Canyon Fuel Company, LLC. Skyline Mine

RE: Application to Reduce Water Monitoring requirements at Selected Water Monitoring Sites, Canyon Fuel Company, LLC, Skyline Mine, C/007/005

Title: Reduced Water Monitoring

**Figure B**  
**F-9 and F-10 Flows**

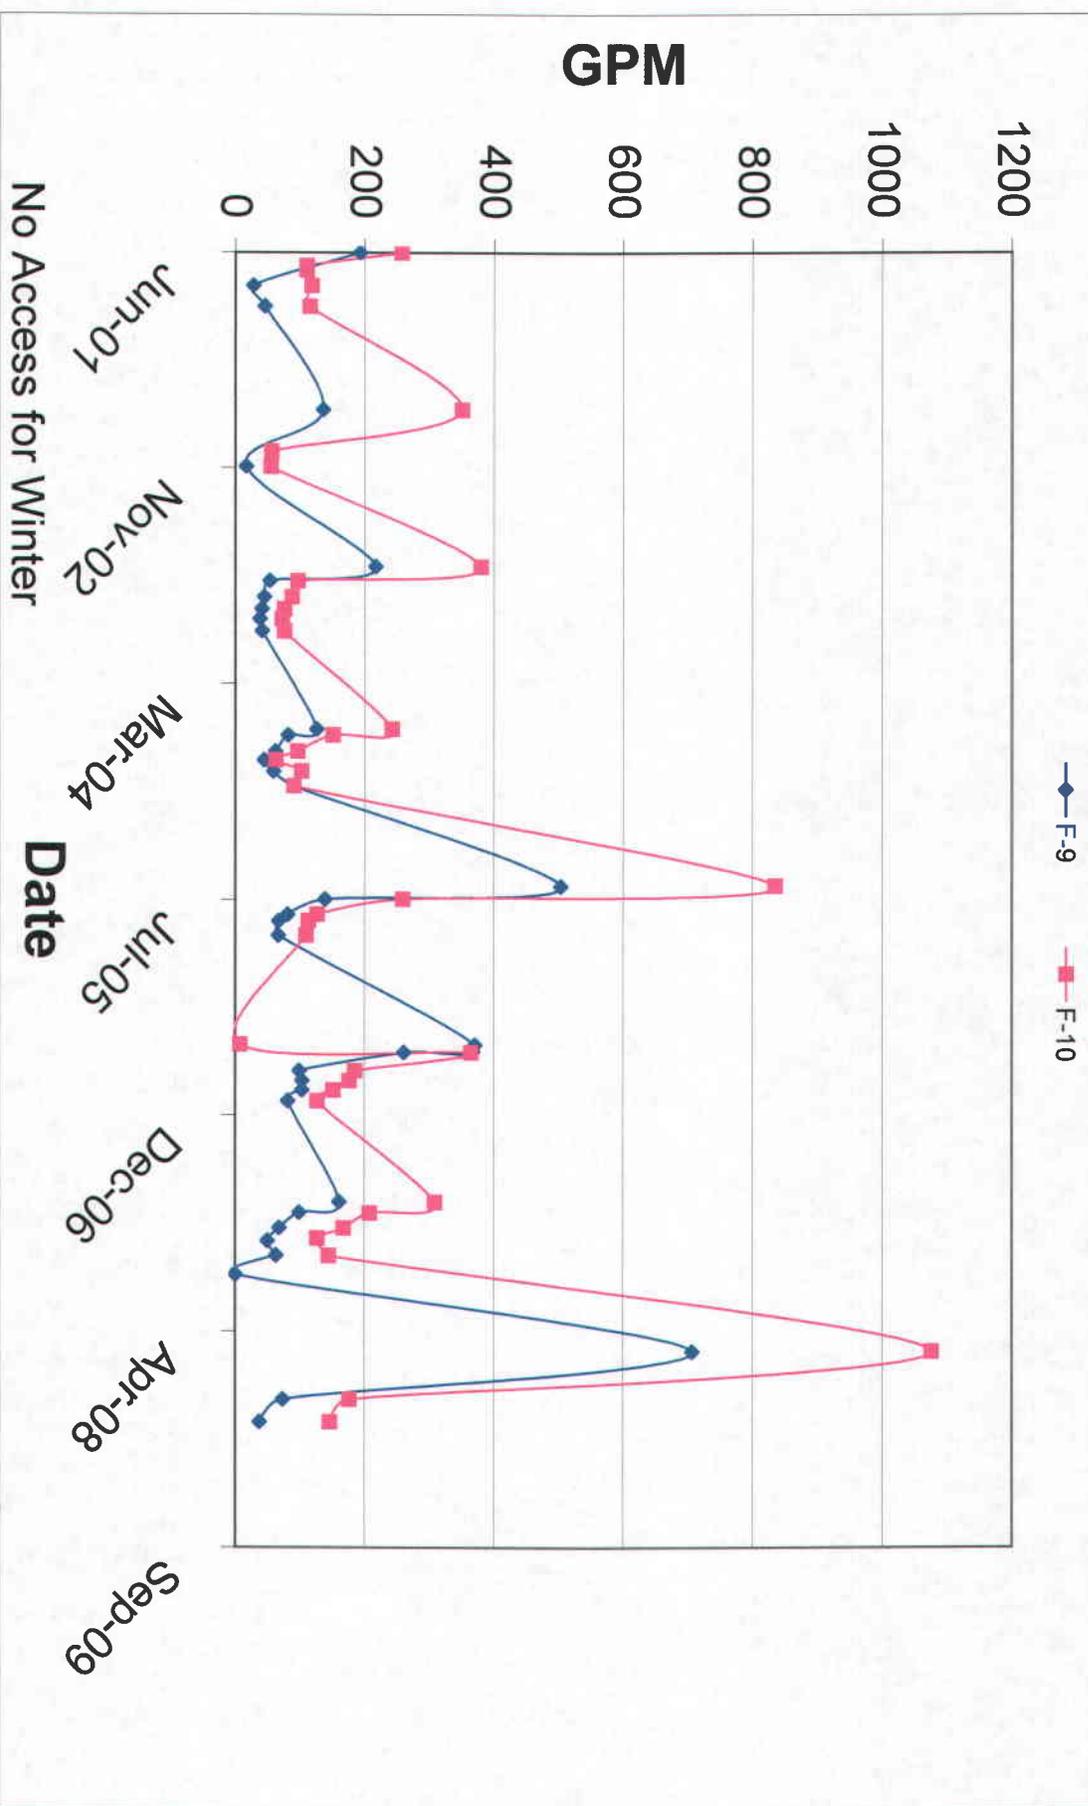
**F-9 and F-10** – These two (2) stream sites are located on James Canyon Creek below JC-1. The initial monitoring purposes of these sites were two-fold; one to monitor monthly stream flows while undermining of the streams was taking place; the other to monitor activities of the JC-1 construction. Mining in the vicinity of the stream was completed a number of years ago and the mine has subsequently been flooded. Data for the flow monitoring of these sites are illustrated in Figure B. Figure B illustrates that both no notable impacts were observed through

either mining or with the James Canyon wells, and that the flows from F-9 are proportion to F-10 providing limited additional information.

It is proposed that 1) F-9 be discontinued on the basis it provides only limited additional information as compared to F-10; and 2) that monitoring requirements at F-10 be scaled back to quarterly flow and field parameters, with water analysis being collected every five (5) years. The proposed scaled back water monitoring commitments are consistent with the current water monitoring program in the surrounding area.

Figure C

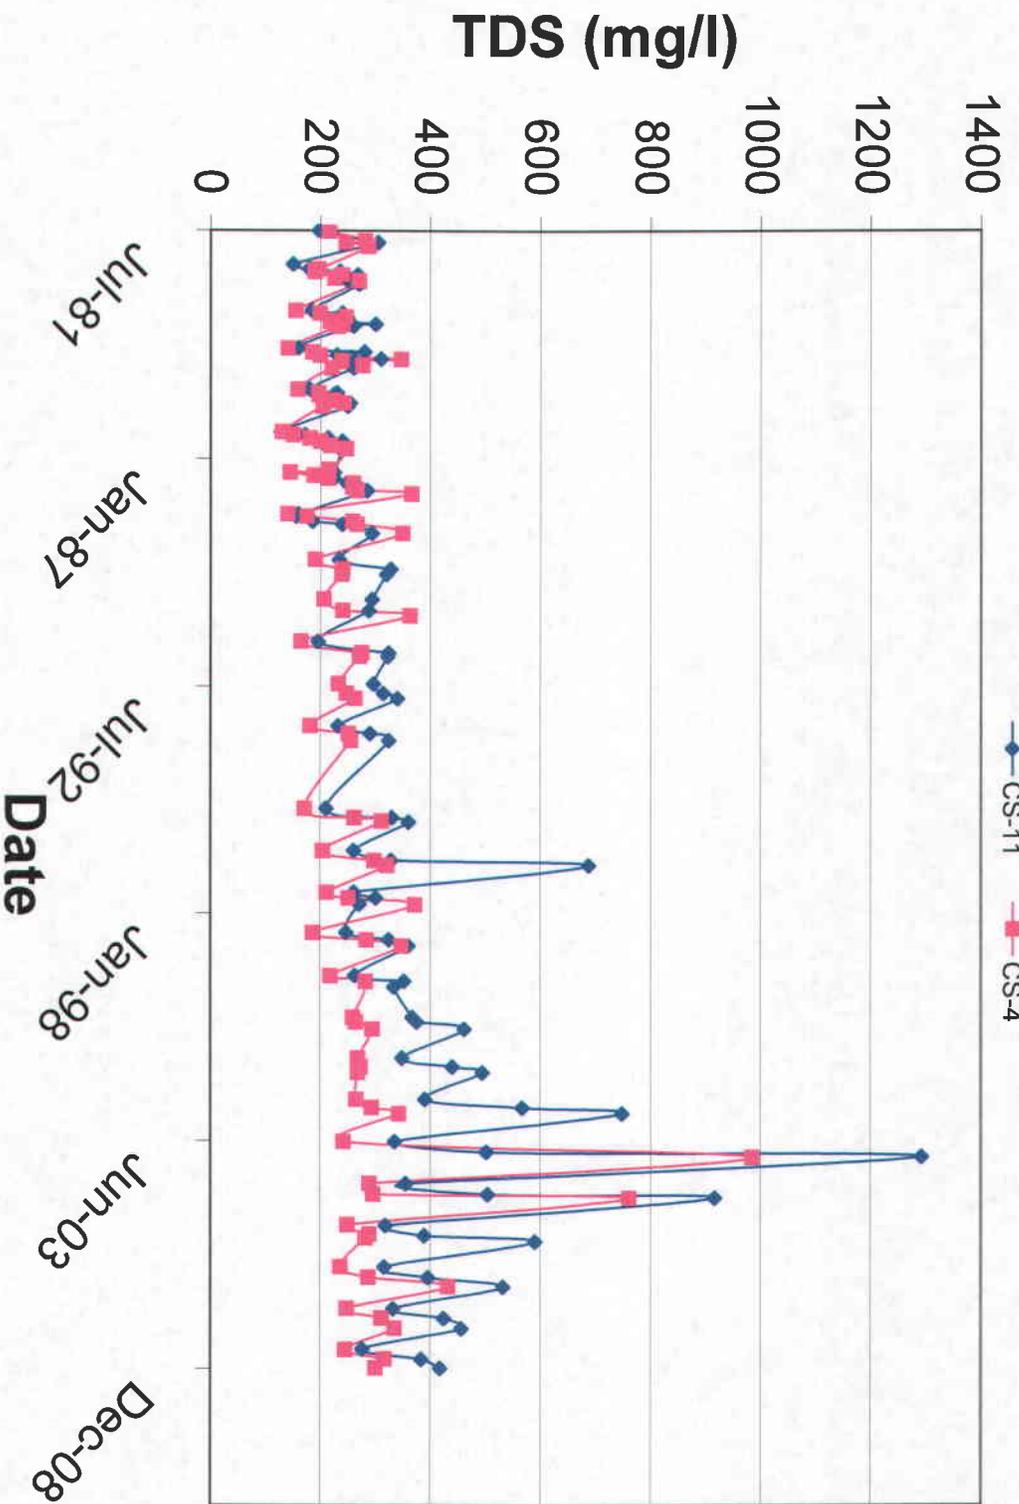
**CS-4** – CS-4 was originally identified as a water monitoring location to monitor both flow impacts related to mining and have a monitoring site located above the Water Tank. Upstream of the Mine site water quality monitoring is adequately monitored by CS-11. Figure C illustrates quarterly water monitoring of both sites beginning in 1979 to today. The Total Dissolved Solids (TDS) data illustrates that although CS-4 has lower concentrations, the chemistry is similar. The higher concentrations noted at CS-11 are easily explained by CS-4 representing roughly 40 percent of the water reporting to CS-11.

It is proposed that F-4 be discontinued on the basis that 1) CS-11 adequately monitors the Upper Left Fork of Eccles Creek above the Mine site; 2) the mining in the vicinity on the drainage was conducted over a decade ago with no observable impacts; and 3) that the existing 30 years of quarterly monitoring adequately characterized the sub-basin of CS-4.

Figure D-1

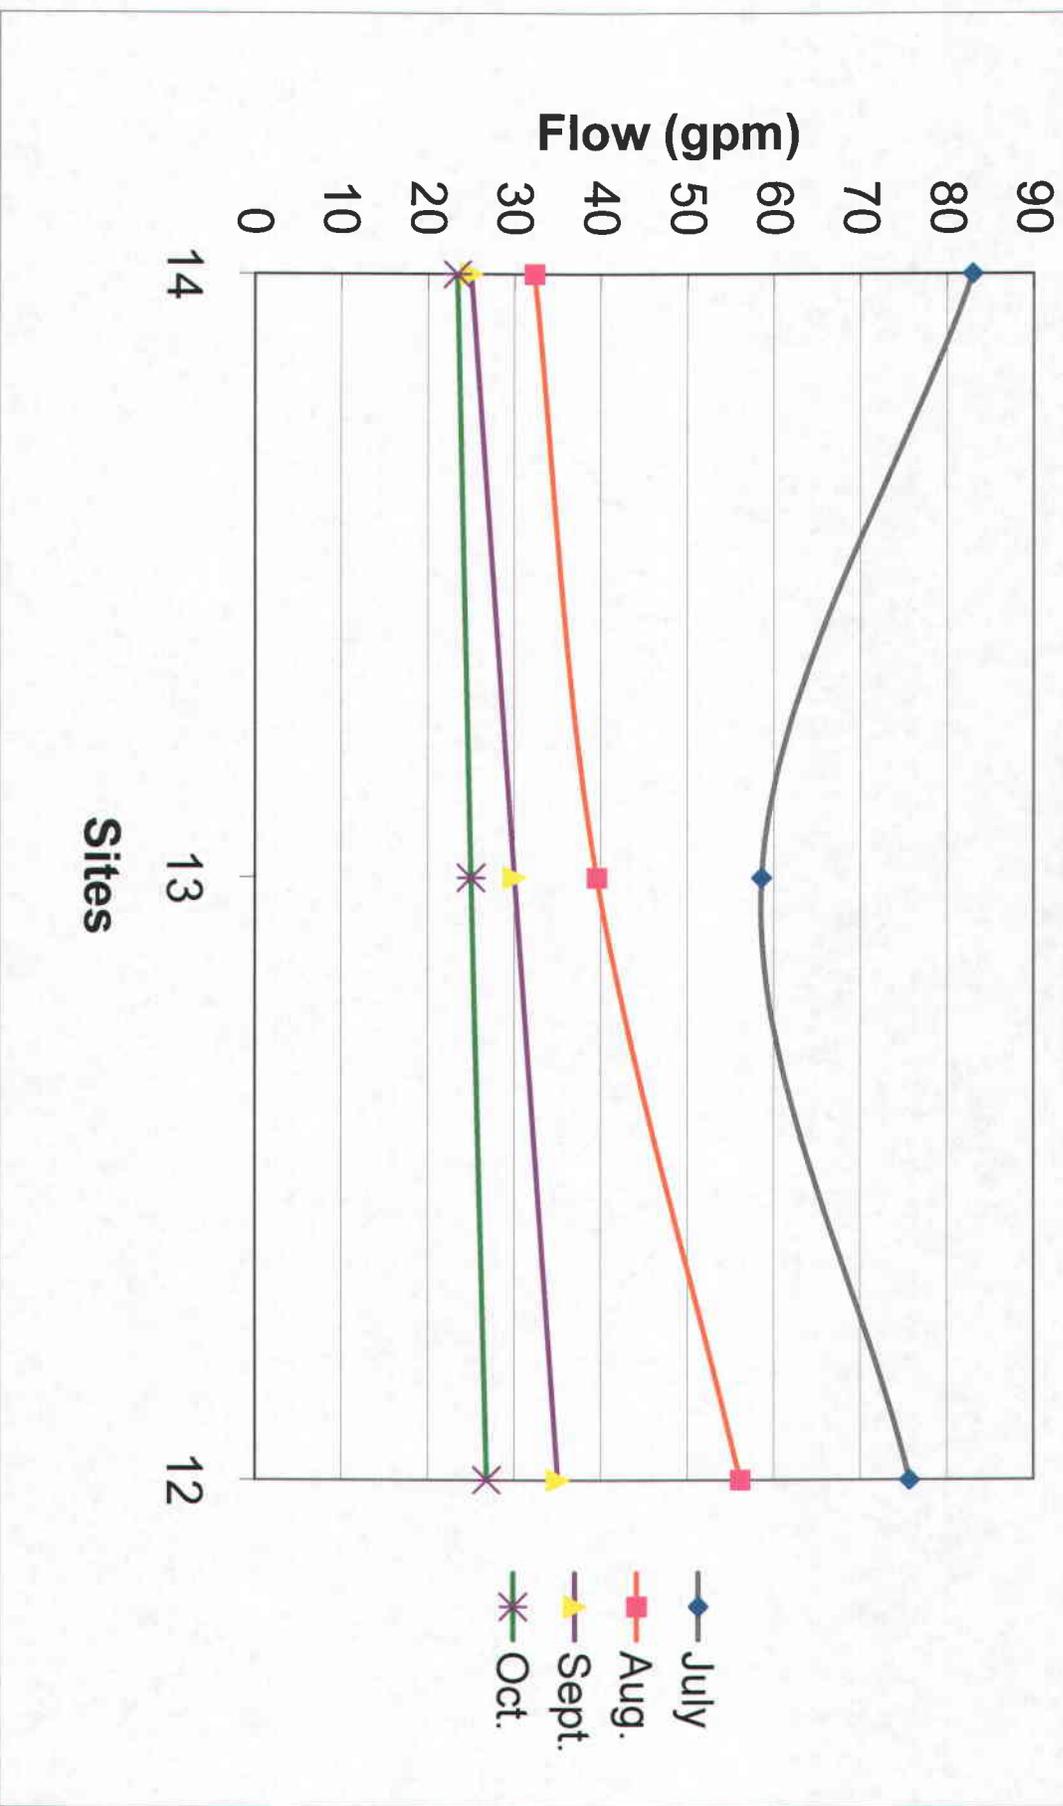
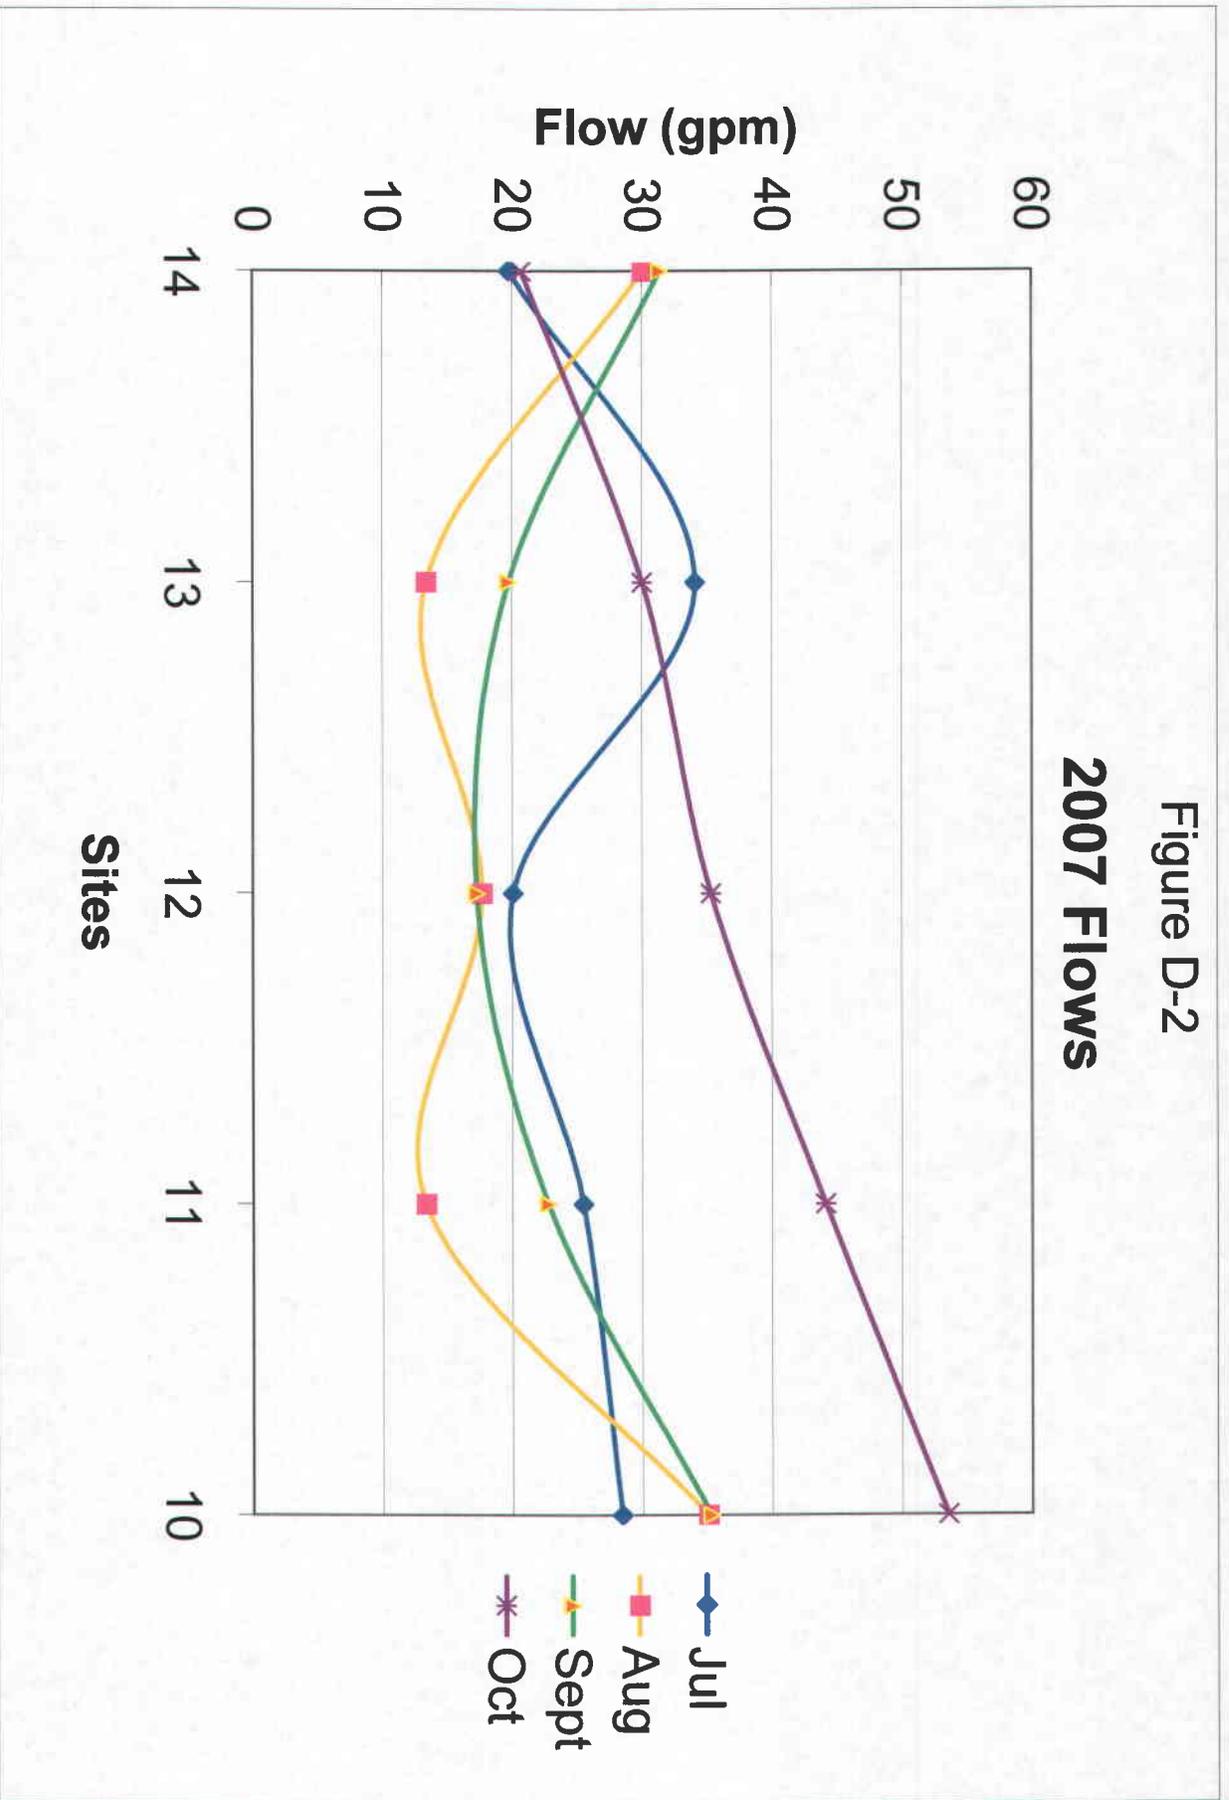
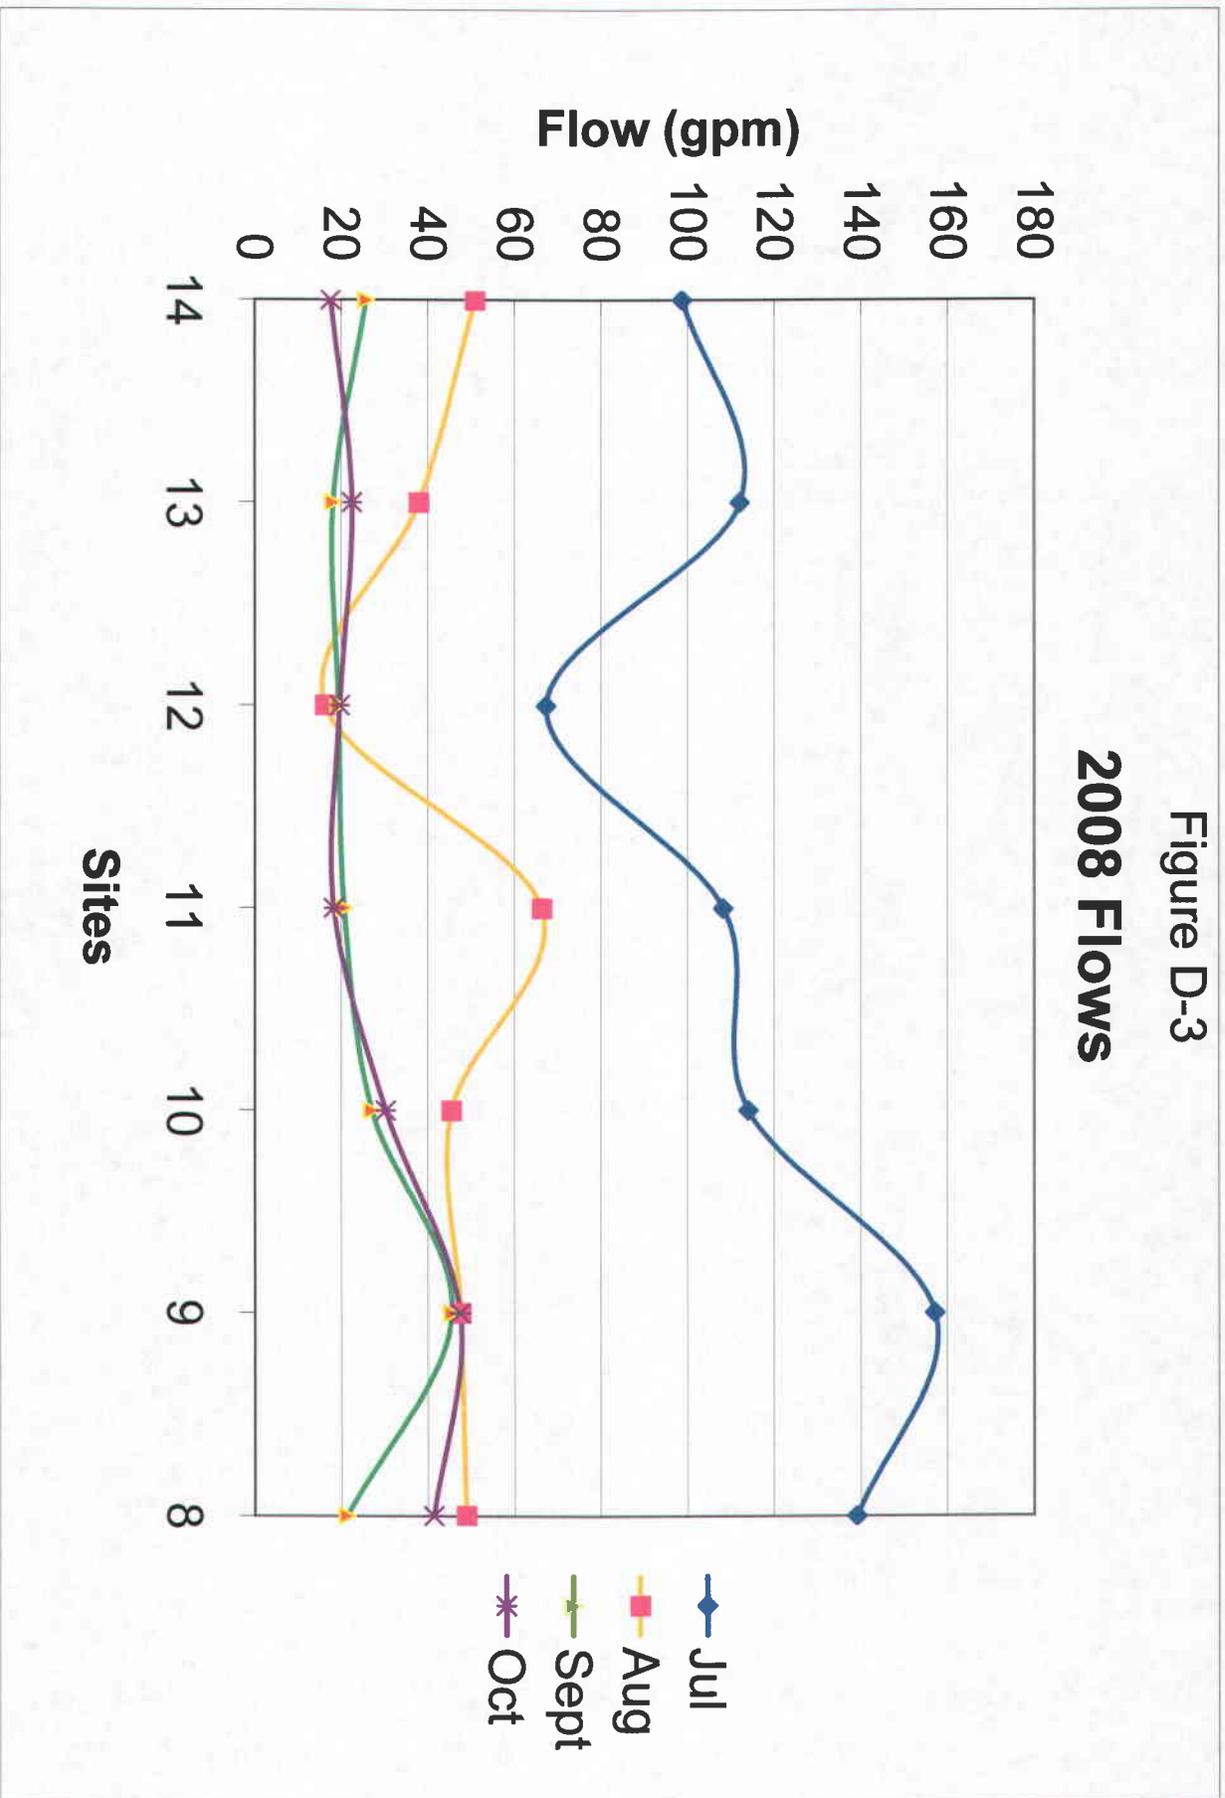
**NL sites (NL-13, NL-14)** – As outlined in Section 2.4.4 of the currently approved M&RP, NL sites are designed to monitor stream flow in perennial stream before, during, and after the stream has been undermined with longwall mining to identify whether any observable impacts or loss of water is noted in the stream as related to subsidence. Sites NL-12 through NL-14 were established to monitor any potential affects to the stream while undermining the 1-Left panel, which completed undermining of the creek in November 2006. As outlined in the monitoring program, sites NL-13 and NL-14 are due to be discontinued from monitoring having completed the required monitoring. Figures D-1 through D-3 illustrate the measured flows for years 2006 through 2008, respectively. Although flows were collected in June in 2007 and 2008, the data is not included to better scale the graphs, and better illustrate the true flows since June flows are highly influenced by snowmelt. Although there is inherent variability in the data from site to site and from year to year, the data consistently illustrates that the flow is increasing downstream, and there are no significant losses to stream flow.

It is proposed that monitoring sites NL-13 and NL-14 be discontinued from the monitoring program as outlined in Section 2.4.4.
